REFERENCE LHC-EQCOD-EC-XXXX

ENGINEERING CHANGE REQUEST

Installation in IR2 of dispersion suppressor collimators (TCLD)

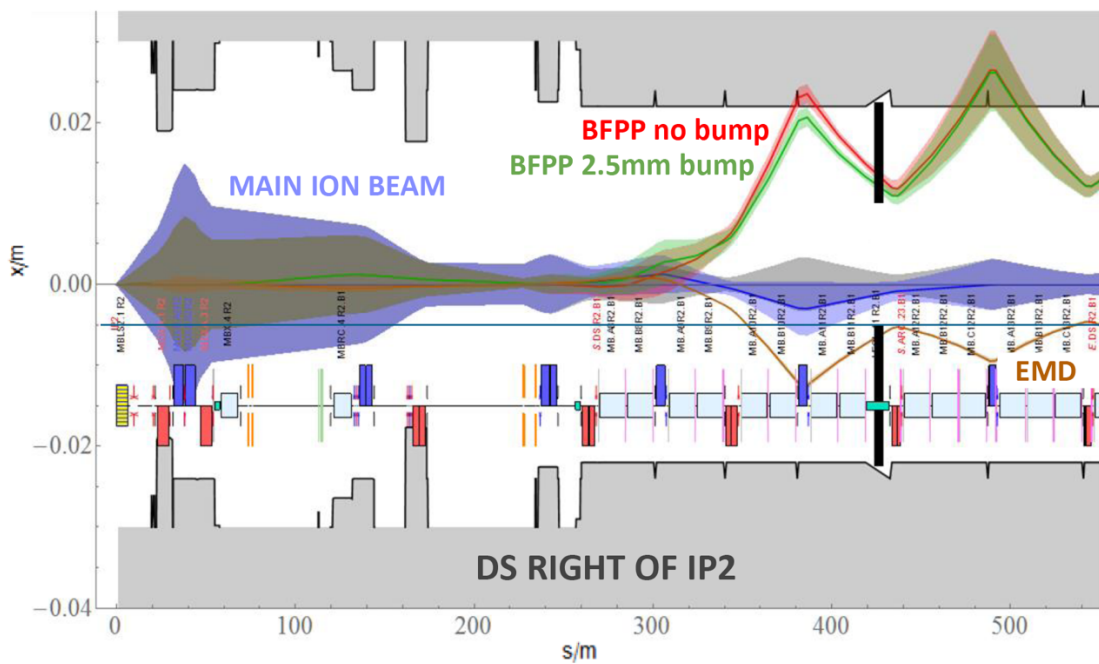
The magnets that are impacted by these losses are likely to quench at the high luminosities foreseen for HL-LHC. As alleviation, it is planned to install additional collimators (shown as black lines in Figure 1).

As can be seen in Figure 1, these secondary beams are lost very locally due to the large and sudden change of magnetic rigidity at the interaction point. After the LS2

ALICE upgrade, aiming at a peak luminosity of $6 \times 10^{27} \text{cm}^{-2} \text{s}^{-1}$ (about six times higher than the nominal one) [3], the dominant BFPP1 beam can carry about 155 W, resulting in a power load in the coils of the MB.B10 dipole of about 44 mW/cm^3 [4] on both sides of ALICE. Similar ion losses also occur in the DS regions around ATLAS and CMS, however at different locations than in IR2. A beam loss experiment carried out during the 2015 Pb-Pb run at 6.37 Z TeV [5] confirmed the long-standing presumption that BFPP1 ions risk to quench magnets [1,2]. The experiment was carried out around CMS because it was running at higher peak luminosity than ALICE. The deposited power during the quench was estimated with FLUKA simulations to be about a factor 6 lower than what is calculated for HL-LHC, hence this effect could be a serious limitation for HL-LHC.

During standard operation, special bumps were deployed around ATLAS and CMS to steer the BFPP1 losses into the locations of the connection cryostat, however, because of the quadrupole polarities in IR2, this solution alone is not possible at ALICE. Instead, the HL-LHC baseline is to install one additional collimator, called TCLD, on each outgoing beam in the IR2 dispersion suppressor, where the dispersion is already rising [3]. Orbit bumps allow making sure that the beam is not lost at the first (lower) dispersion peak (see Fig. 1) and enable shifting the losses into the collimators. These TCLD will also intercept the most powerful EMD beam (EMD1). FLUKA simulations have shown that the proposed TCLDs reduce the peak load on the magnets to tractable levels at HL-LHC design luminosity [4].

Figure 2 —Positions of new TCLD collimators in IR2. Figure taken from Ref. [6].

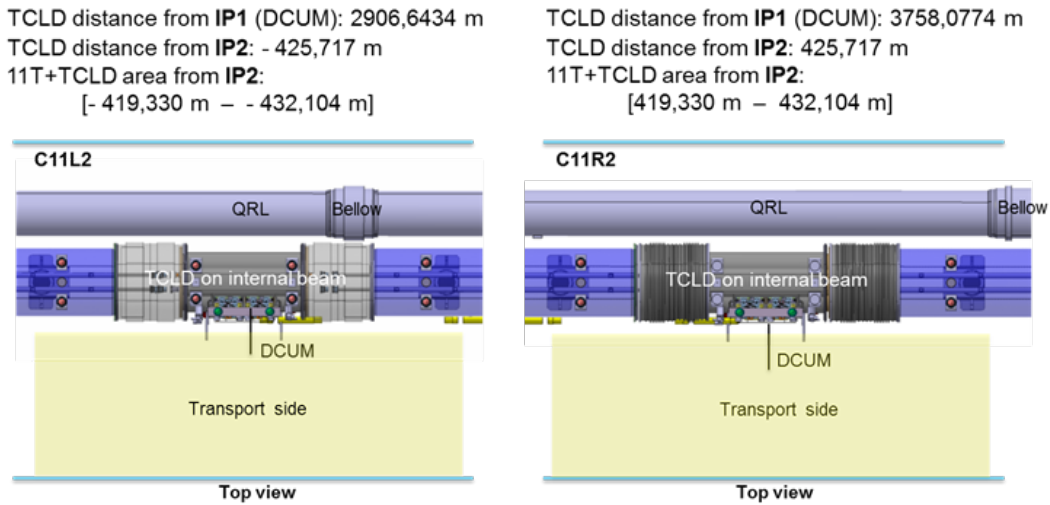
The most loaded magnet in IR2 is MB.B10 on each side. The TCLD in IR2 can be placed further downstream in the connection cryostat (LECL.11R2.B1 and LECL.11L2.B2). This requires two new shorter connection cryostats to be designed, and in between them, the TCLD assembly will be placed. The connection cryostats are described in a separate ECR under the responsibility of WP11. A drawing of the integration in the area, as well as the absolute positions, is shown in Figure 2. More details on the integration can be found in Ref. [6]. In order to optimize design and production efforts, the design of the TCLD assembly is identical to the one used in IR7.

Figure 3 – Drawing of one of the TCLD jaws (top), including RF fingers, cooling pipes and BPMs, and the two jaws installed on the table (bottom). Courtesy of L. Gentini.

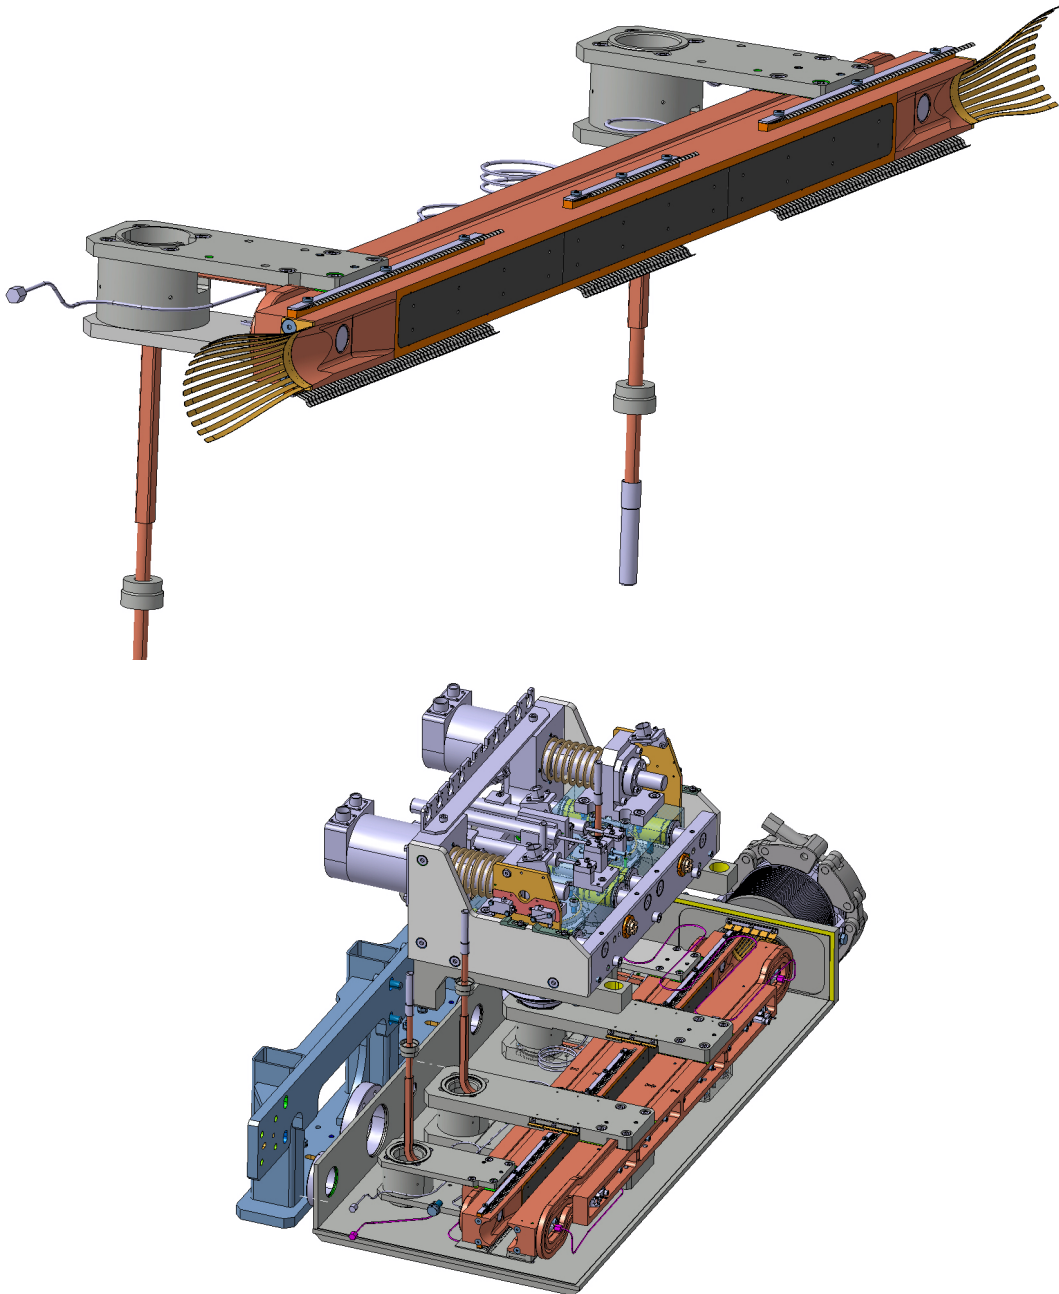
The TCLD consists, as most other LHC collimators, of two parallel jaws collimating the beam in the horizontal plane, with the beam passing in between them. The active material of the jaws is the tungsten alloy Inermet 180. The design of the TCLD collimator, shown in more detail in Figure 3 and Figure 4, is derived from the design of the present LHC collimators, but with some differences. Since the design of the IR2 TCLDs is identical to that of the IR7 ones, and because of the very tight space requirements in IR7, the design is challenging and the active length of the material had to be reduced to only 60 cm, in order to make it fit. This means that also a non-standard support design is used. Furthermore, the bellows at the two longitudinal extremities are integrated in the tank transitions in order to gain longitudinal space. A 3D drawing of the tank and support is shown in Figure 5.

Figure 6 – The assembly to be installed between the two 11T dipoles, consisting of TCLD collimator, support, beam pipe for the other beam, and cryo-bypass. Courtesy of L. Gentini.

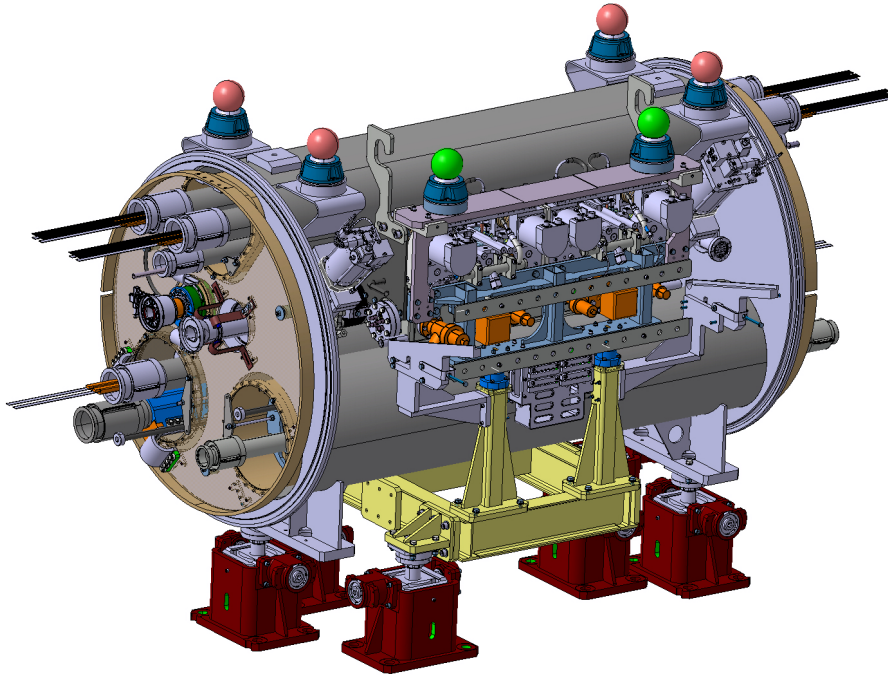
The TCLD will be integrated in a specially designed assembly, containing a beam pipe for the other beam, as well as a cryo-bypass, which is needed since the TCLD is a warm element placed between two cold ones. This assembly, which is discussed more in detail in a separate ECR, is shown in Figure 6.
